# ***Access and facilities for people with disabilities in a tavern***

## **1 THE MATTERS TO BE DETERMINED**

*The relevant features of the toilet facilities*

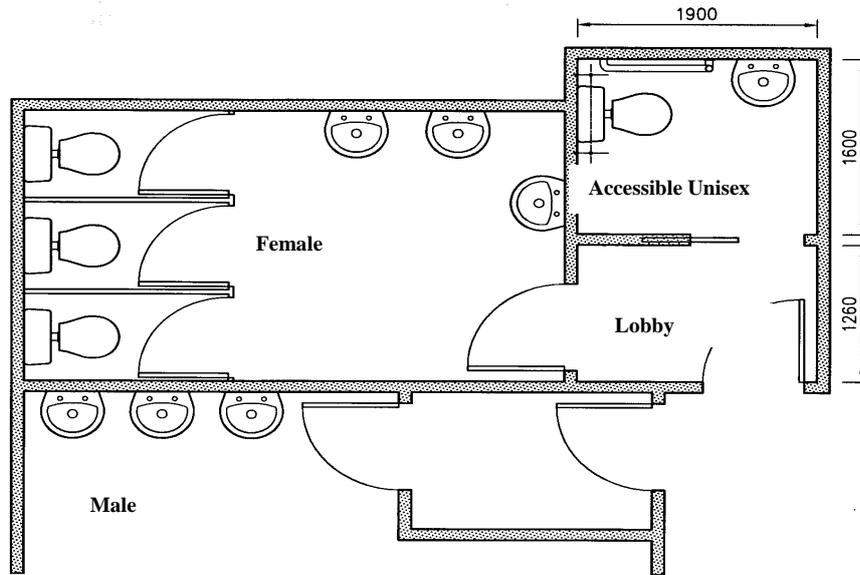
- From the combined female/unisex toilet lobby (general public area) males using the combined lobby can view the toilet cubicles used in the female toilets as there is no privacy screening to the female space containing soil fixtures, alternately females using the lobby can view the soil fixture in the unisex toilet (Fig 10 G1/AS1).
- There is inadequate space or distance to provide an adequate turning circle between the inward opening lobby entry door and entry into the unisex disabled toilet (Fig 27(b) D1/AS1).
- Two raised seating areas for patrons (one a non smoking area) have only stair access, there is no accessible ramped access.
- The Bar has no accessible section.

- 5.2.1 The plan of the toilet facilities as shown on page 2 above, has a combined lobby with plan dimensions of 1900 mm by 1260 mm. The question is whether that provides the necessary manoeuvring space.
- 5.2.2 The owner and the building certifier contended that it did so on the basis of Figure 14 of NZS 4121:1985 (set out below).
- 5.2.3 Figure 14 of NZS 4121:1985 does not appear in NZS 4121:2001. In any case, the figure does not show the combination of inward-opening door and sliding door used in the lobby, and does not allow for two or more people to be in the lobby at the same time, as could well be the case because the lobby serves two separate toilet compartments. In that respect, the Authority considers that the lobby must be treated as a corridor.

5.3.3 The owner and the building certifier said that the lobby was not a public area. The lobby complied with paragraph 6.3.1 in that it led to both female and unisex facilities and so was not required to be a single sex lobby. The Authority disagrees. Paragraph 6.3.1 must be interpreted so as to achieve the purpose of clause G1.3.2 of the building code, namely preserving privacy. That cannot be achieved by the provision of a lobby to single-sex toilet facilities if the lobby is to be used by both males and females.

5.3.7 From comparison with the examples shown in Figure 10, the Authority considers that the lobby concerned does not provide appropriate privacy for the users of either the female toilets or the accessible toilet.

5.2.6 The Authority therefore concludes that the lobby does not comply with clause D1.3.4 of the building code in respect of manoeuvrability.

5.3.8 The Authority concludes that the toilets do not comply with clause G1.3.2 of the building code

Figure 27(b) of D1/AS1.

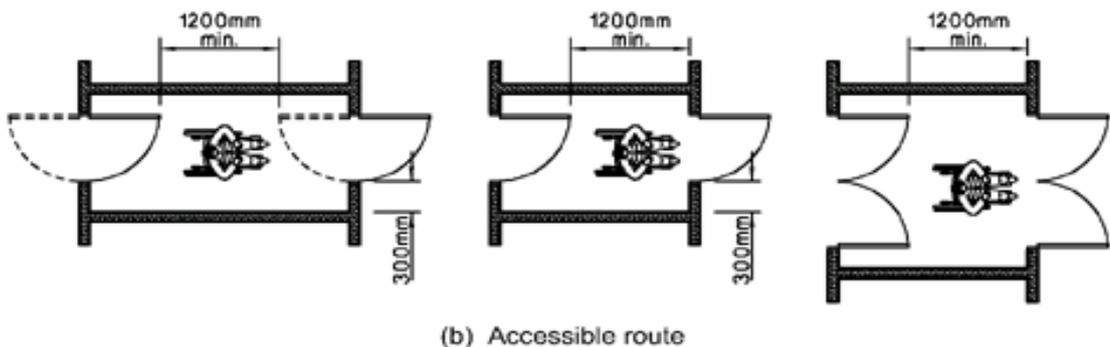
5.2.5 The applicant referred to Figure 27(b) of D1/AS1 (see below), which is very similar to Figure 19 of NZS 4121:2001 (see below), but again neither of those figure shows the combination of a side-hung door and a sliding door as used in the lobby concerned. Nevertheless, from the dimensions shown in those the Authority considers that there is insufficient space in the lobby to ensure that wheelchair users can conveniently enter through the side-hung door then close that door before opening the sliding door into the toilet compartment, particularly if an ambulant person wishes to use the lobby at the same time.

Figure 10 of G1/AS1

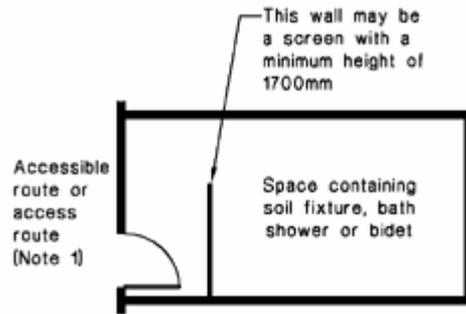
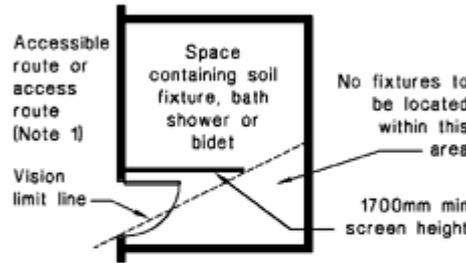
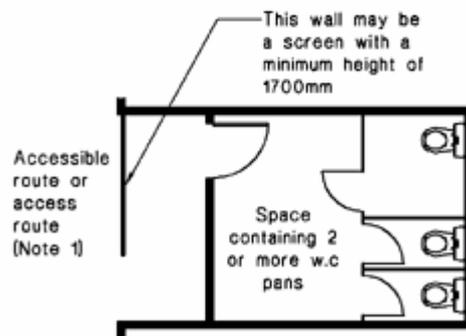
5.3.5 The applicant referred to Figure 10 of G1/AS1, which should be read with paragraph 6.1.1 of G1/AS1:

**6.1.1** There shall be no direct line of sight between a general public area and a WC, urinal, bath, shower or bidet. See Figure 10 for acceptable layouts.

5.3.6 G1/AS1 is an acceptable solution but is not the only means of complying with the building code's requirements for privacy. (Figure 10 is not concerned with manoeuvrability for wheelchair-users, which comes under clause D1 of the building code as discussed in 5.2 above.)

Figure 37 of NZS 4121:2001\*

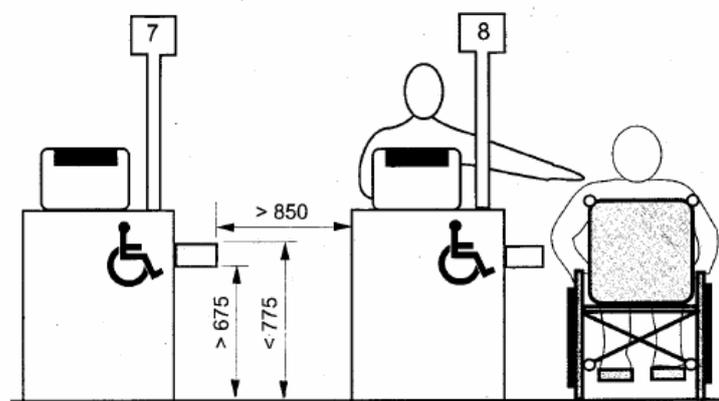
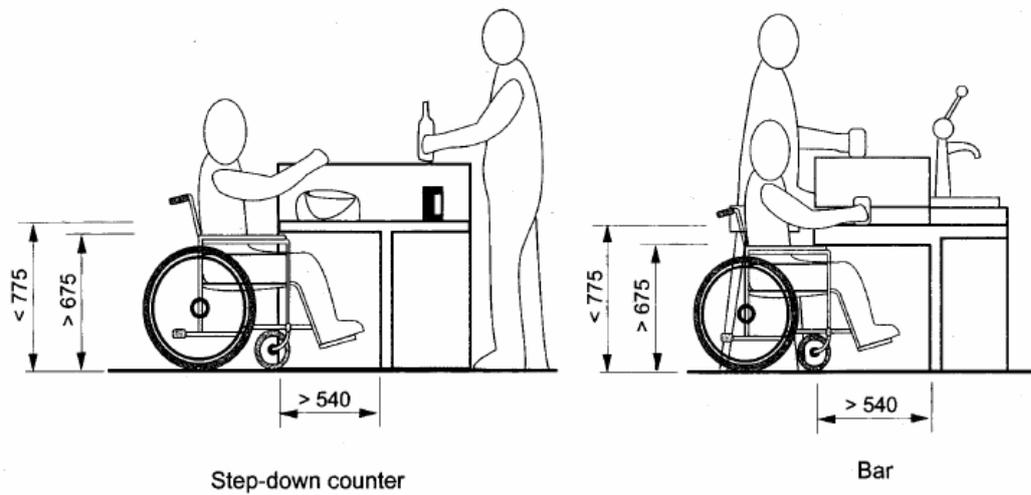
Additional examples of public counters such as in public bars, shops, supermarket checkouts shall comply with 11.1.1 as shown in figure 37.

5.5.5 The Authority accepts that staff of the tavern will generally attend to people with disabilities. Nevertheless, the bar makes no provision whatsoever for wheelchair-users, so that it clearly is not an alternative solution that complies with the building code even though it does not comply with NZS 4121:2001. The Authority accordingly considers that the bar does not comply with clause G5.3.4 of the building code.
